# CITY OF ALBUQUERQUE

**RE: 8615 Mesa Rain NW  
Grading and Drainage Plan  
Engineer's Stamp Date: 9/26/25  
Hydrology File: H09D017A4  
Case # HYDR-2025-00346**

Based upon the information provided in your submittal received 09/26/2025, the Grading and Drainage plan is **not approved** for Building Permit. The following comments need to be addressed for the approval of the above referenced project.

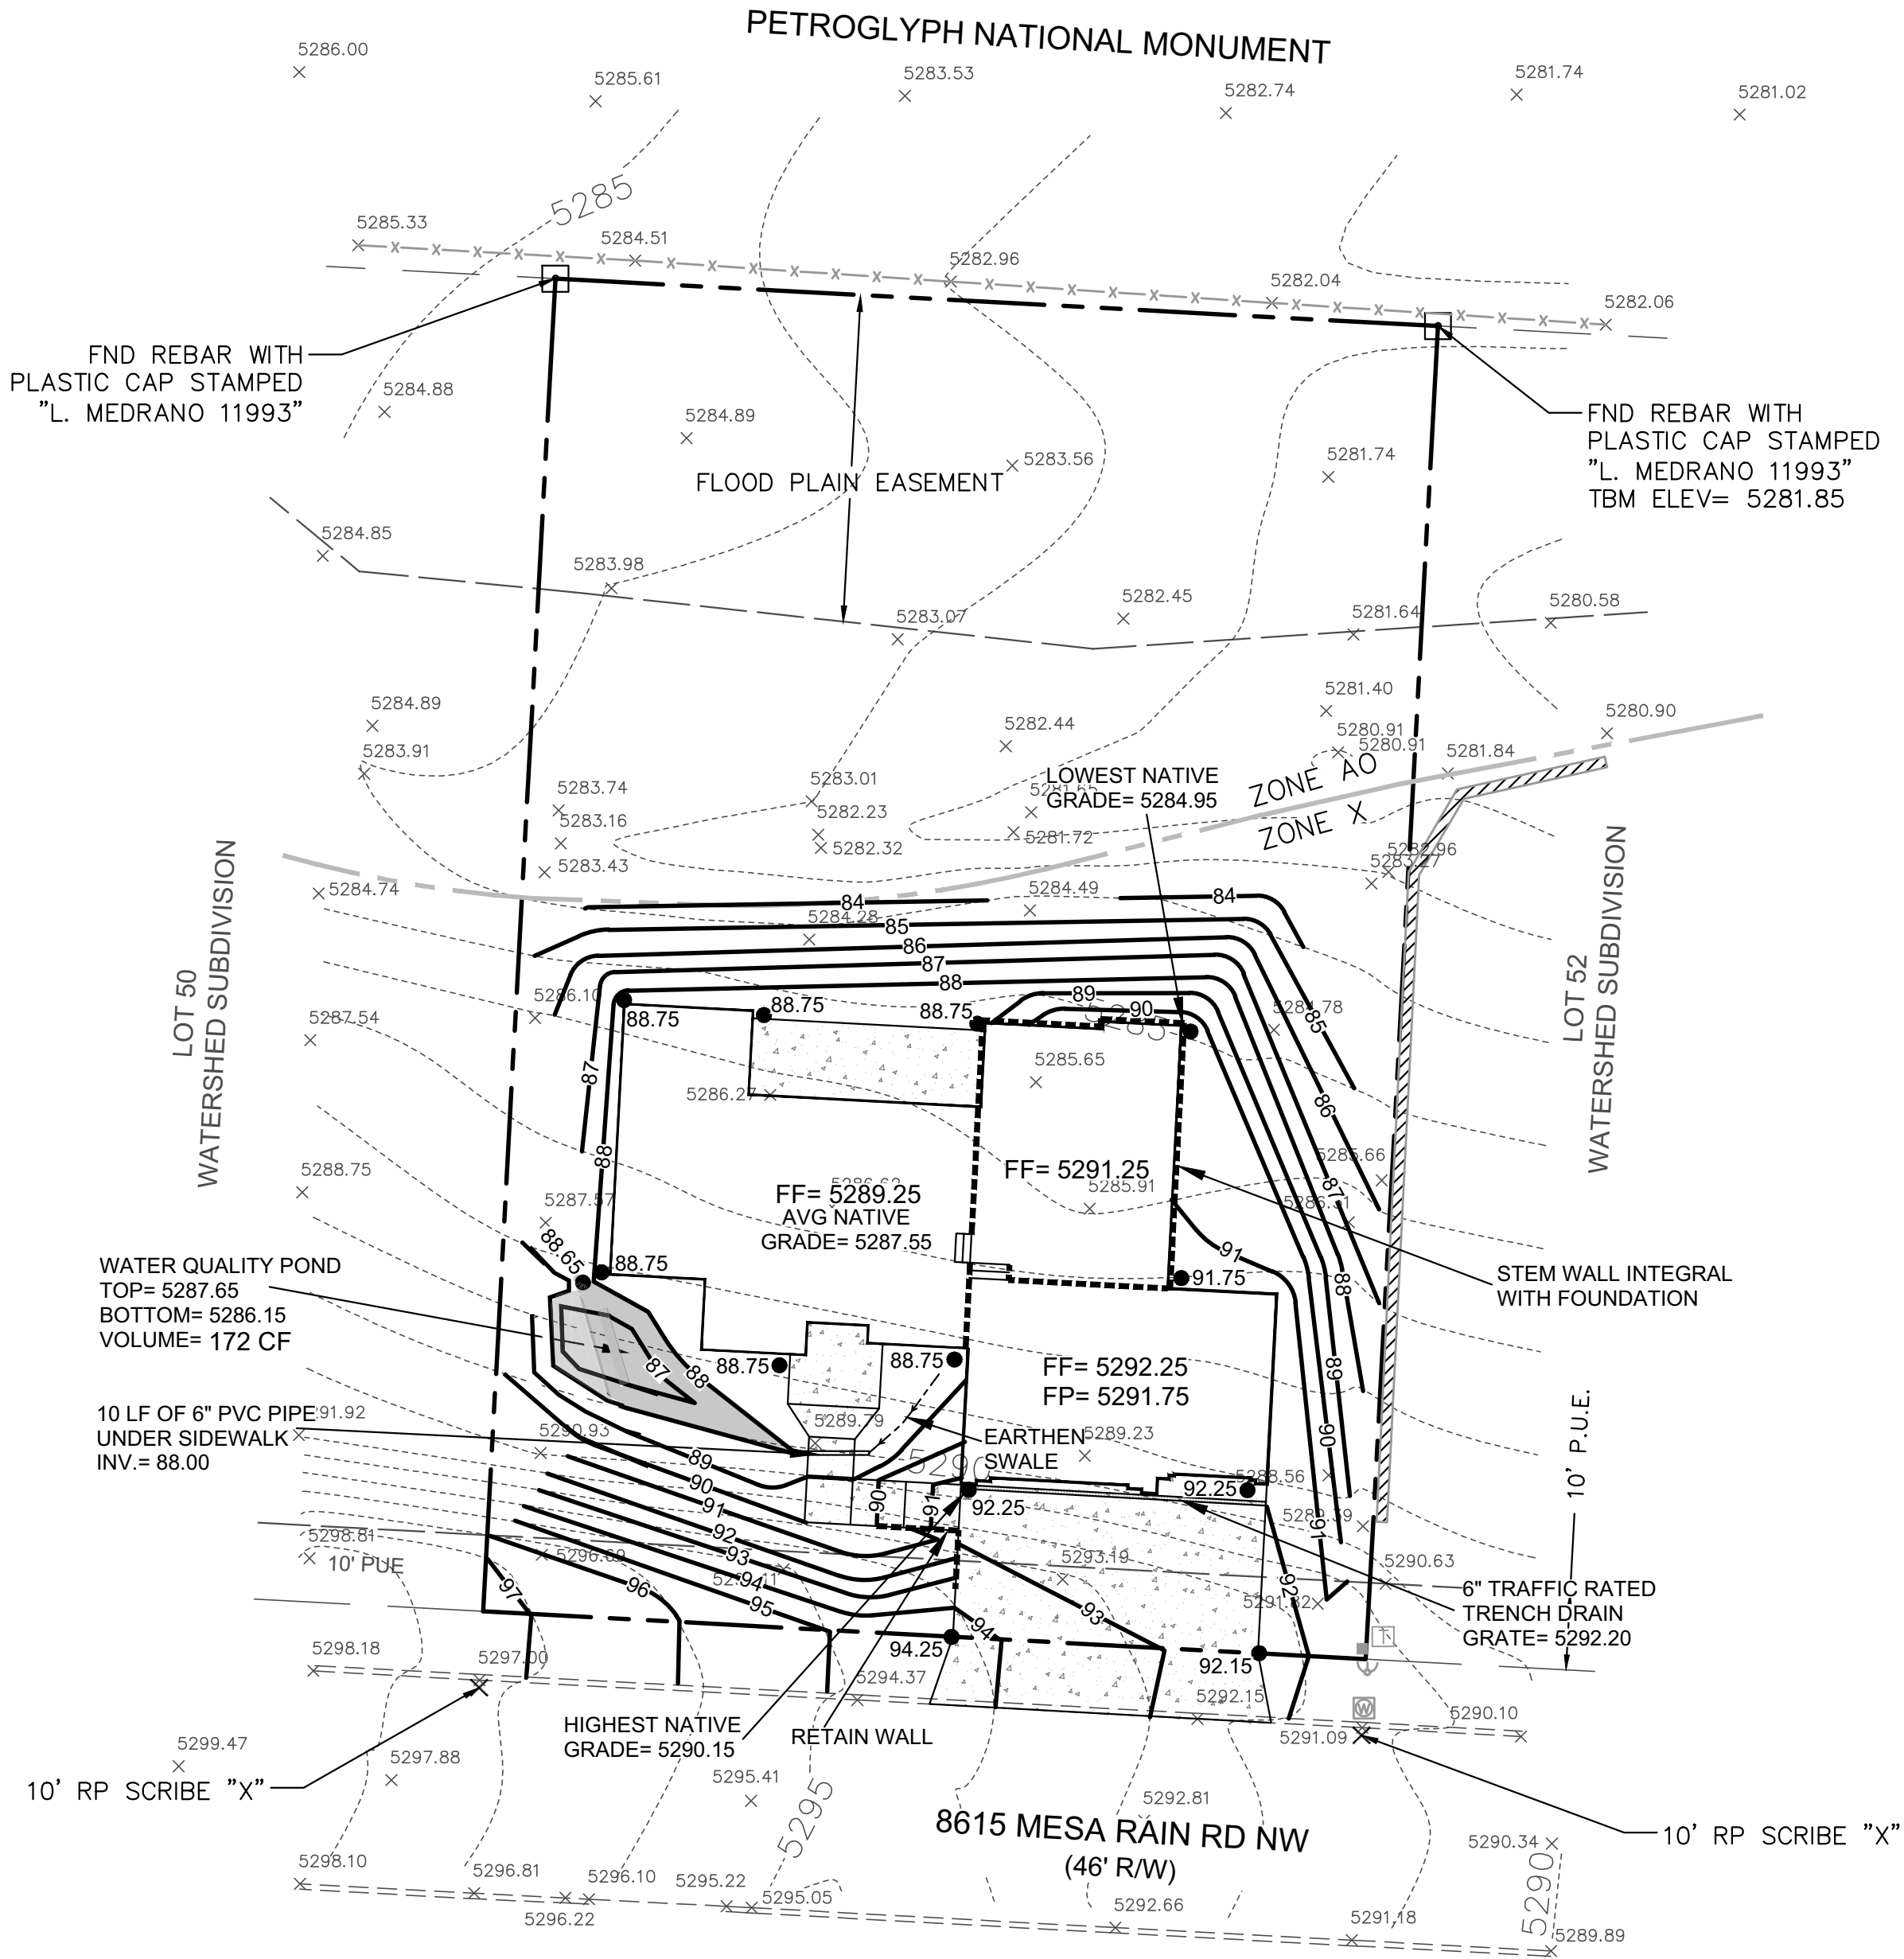
1. A portion of this project is located in a floodplain (AO-1') and a floodplain development permit must be obtained. The permit application must demonstrate zero rise to the base flood elevation, unless a Letter of Map Revision (LOMR) is being prepared. Please contact Rudy Rael, CFM for more information regarding floodplain development permits (rrael@cabq.gov or 924-3977).

2. Provide the base flood elevation for the SFHA on the plan.
3. Since the structure is not encroaching into the SFHA, a pad certification will not be required. Please remove Note #6.

4. Perimeter Walls – Will there be any construction of perimeter walls around the development? If so, please show the walls, elevations, and details on the plan.

5. Per the IDO, the property owner of the property is responsible for building the adjacent half of Mesa Rain to include curb & gutter, and sidewalk. The project will have to go to the Development Facilitation Team (DFT) for approval of the Infrastructure List.

6. Please show the existing and proposed curb & gutter, and sidewalk on the plans.
7. An SO-19 Permit will be required and should be included on the request. Please include the [standard SO-19](#) notes on the grading plan.

8. Per DPM Part 6-4(E), please specify the means of erosion control on the plan for any disturbed areas.
